**UIL HOLDINGS CORPORATION**

Re: Petition No. 1120 – The United Illuminating Company Petition for a Declaratory Ruling that no Certificate of Environmental Compatibility and Public Need is Required for the Proposed Modifications to the Hawthorne Substation at 180 Hawthorne Drive, Fairfield, Connecticut

Please find enclosed the original and fifteen (15) copies of The United Illuminating Company's ("UI") responses to Intervenor Arthur Tournas' Third Set of Interrogatories, dated March 16, 2015 in connection with the above-referenced Petition. Additionally, UI will electronically file all responses and attachments via [siting.council@ct.gov](mailto:siting.council@ct.gov).

PETITION 1120  
ATTACHMENT TOU-III-11-A  
HAWTHORNE – FENCE LINE DISTANCES

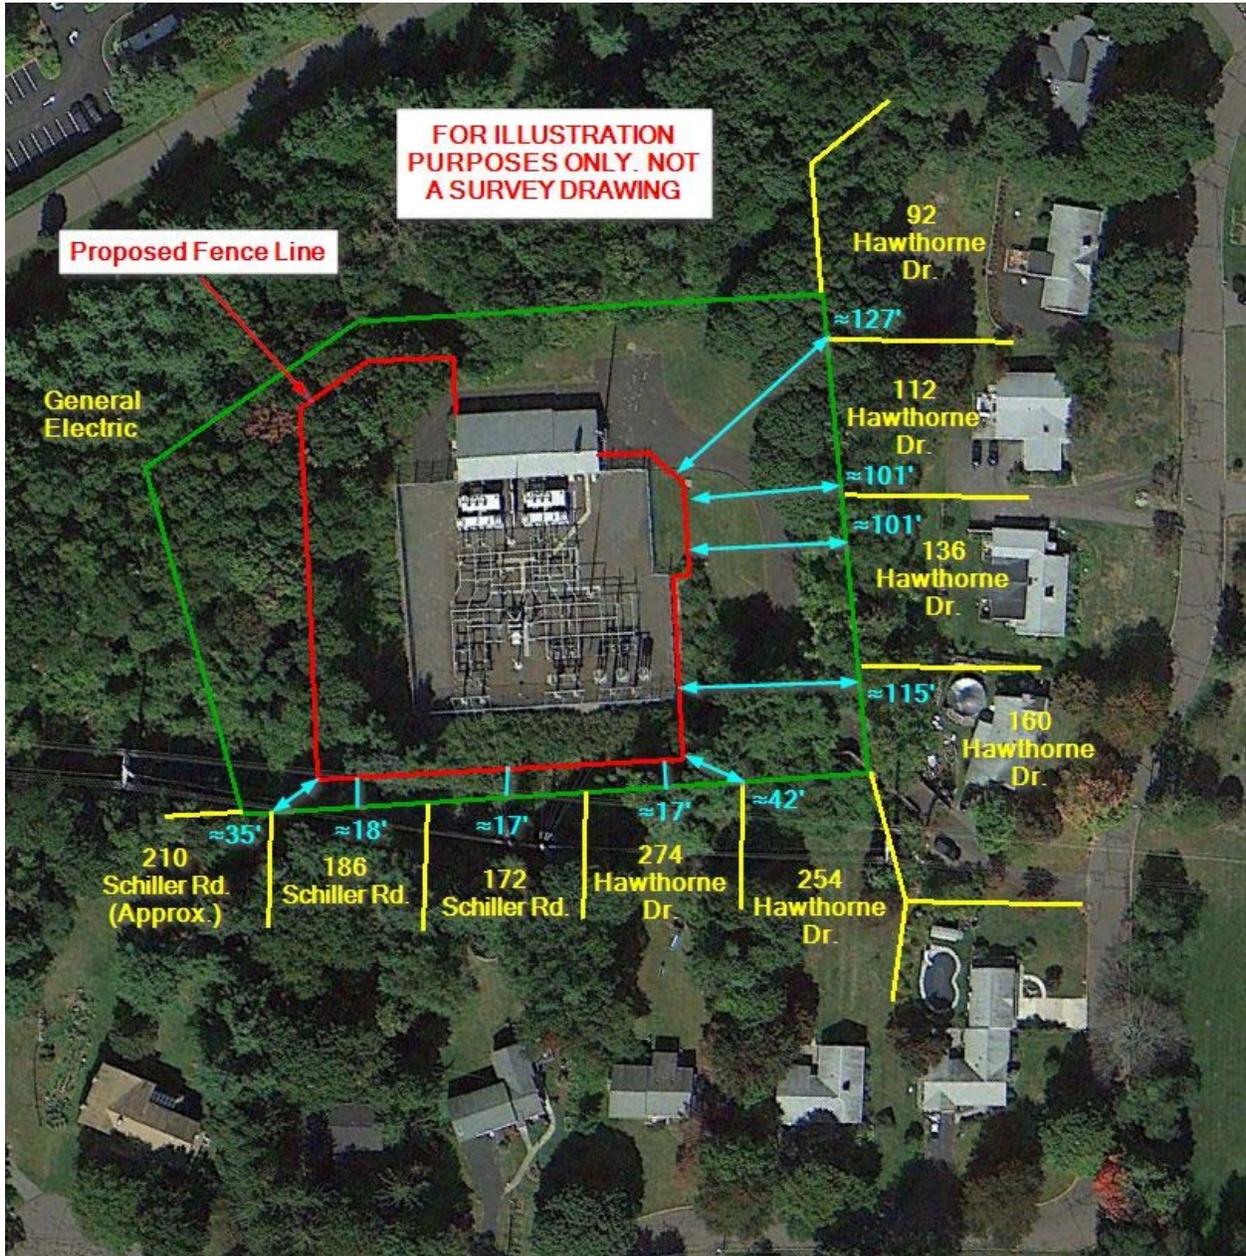
Q-TOU-III-11: Regarding the proposed fencing, please provide the exact location and placement of the fencing on UI's Photo with each abutter's property line. Please show addresses. Please provide the distance from each abutter's property line.

A-TOU-III-11: See Attachment TOU-III-11-A – Fence Line Distances.

PETITION 1120  
ATTACHMENT TOU-III-14-A  
HAWTHORNE – TREE AND SHRUBBERY CLEARING

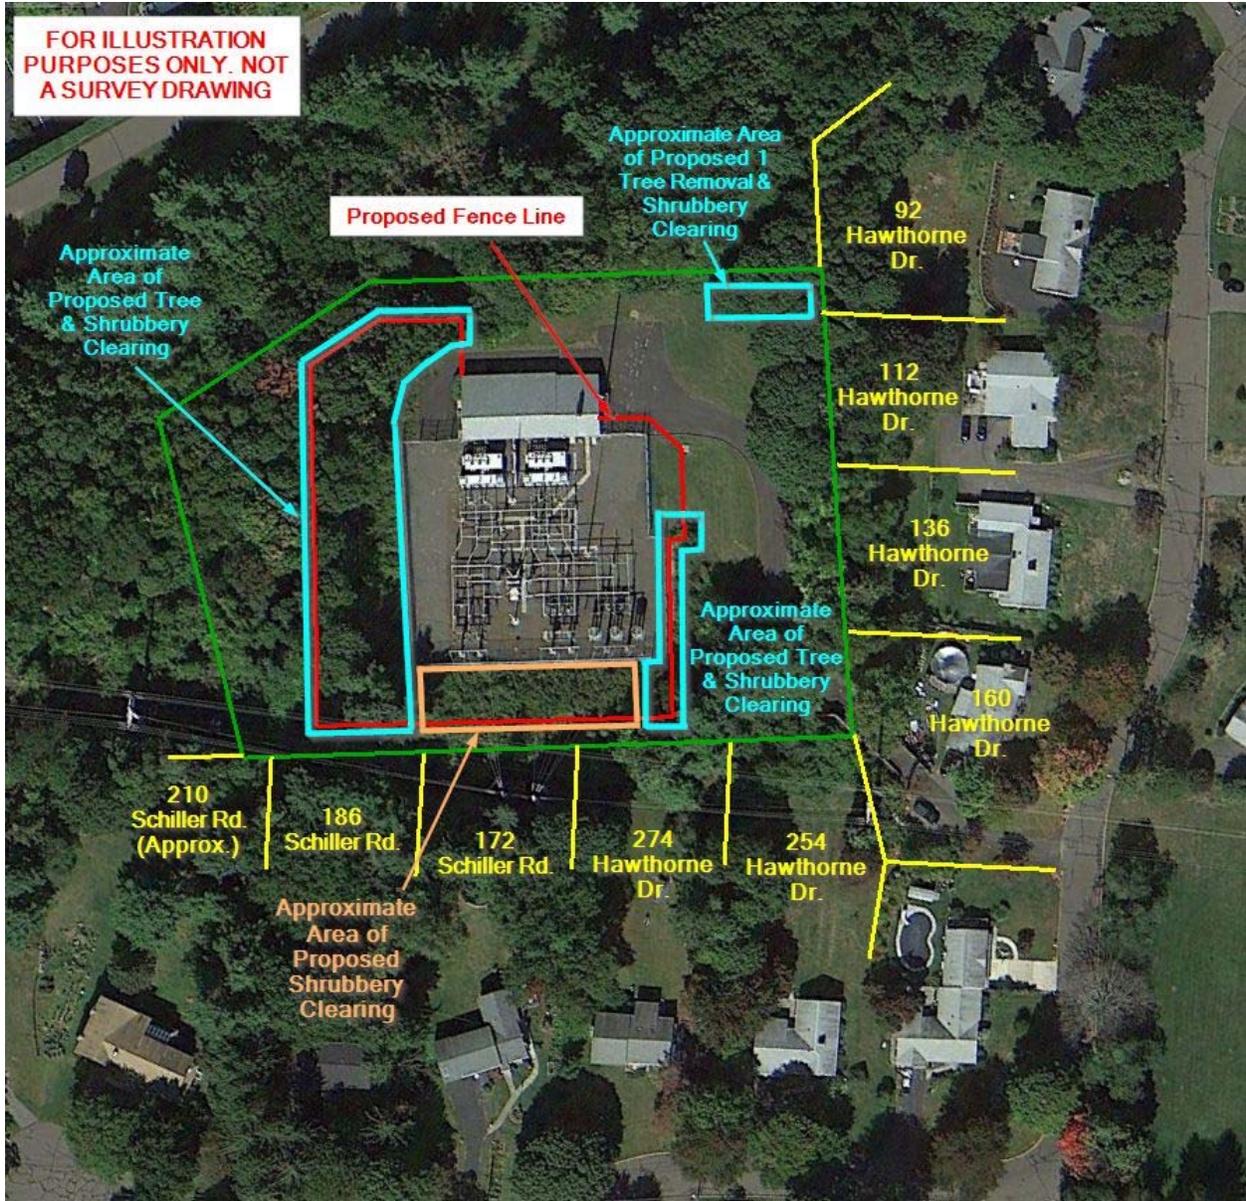
Q-TOU-III-14: Regarding the tree and shrubbery clearing amid Schiller Road and General Electric (3135 Easton Turnpike); what is the exact amount of trees and shrubbery being removed? Please indicate the location of the trees being removed on UI's Photo.

A-TOU-III-14: See Attachment TOU-III-14-A - Tree & Shrubby Clearing.
